SERVICE INFORMATION LETTER

DATE: October 3rd, 2018 **SIL-003/SZD/2018**

SUBJECT: Connections at elevator's drive in SZD-54-2 „Perkoz” sailplanes.

MODELS AFFECTED: All S/N of SZD-54-2 „Perkoz” up to S/N 542.A.18.021W (included).

Pic. 1 Control's drives inside the cabin

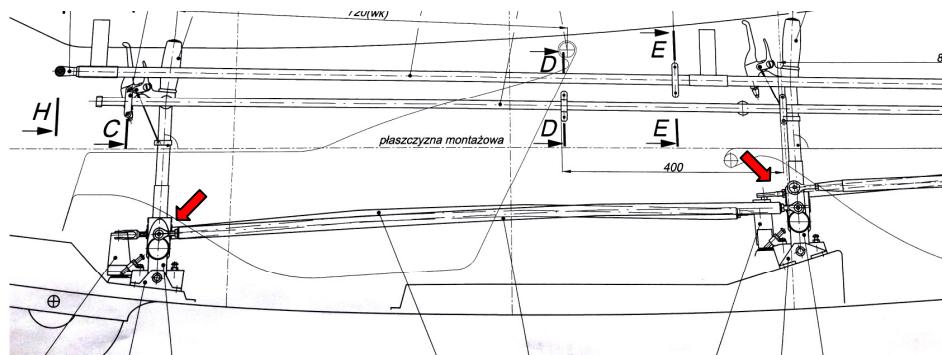
1. Check visually of all the connections on the elevator's drive inside the cabin:
 - remove the front control's stick cover;
 - remove the seat pan from the rear seat;
 - check the connections of both flying controls with appropriate push-rods, as show on Pic. 1 (red arrows):

Put your attention on:

- type and conditions of applied nuts (the type of nuts approved to use are: **H-M6** acc. to BN 73/1117-01 or **M6** acc. to DIN 980V, ISO 7042, NF E25410 or BS 4929-1). The nuts should not be used twice, in case of prior-disconnection of drive;
- the number of protruding threads should be min. 1,5 threads or – in case of thread depth is measured – not less than 1,5 mm.

In case of found discrepancies to the above conditions, correct as necessary.

After screwing the connections, the marking by paint is recommended.

Pic. 2 Connection of elevator's drive in the rear part of fuselage

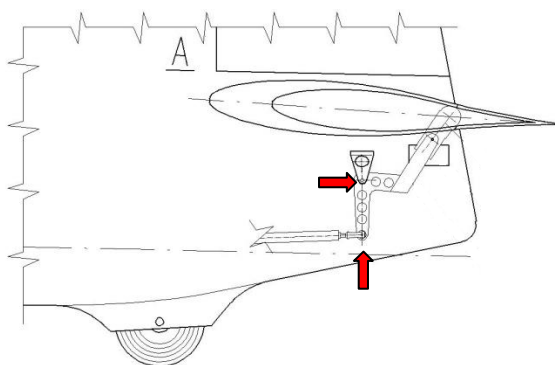
2. Check visually the conditions of connections in elevator's drive in the rear part of the fuselage, as show on Pic. 2 (red arrows). Please note: an access is limited, use a mirror, boroscope or flashlight:

- de-rig/remove the horizontal stabilizer from the sailplane;
- check an evaluate the conditions of fixing of angular lever of elevator as well as the connection of elevator with mentioned angular lever, as per item 1 of this SIL.

In case of discrepancies found, please contact techsupport@szd.com.pl to receive individual instructions.
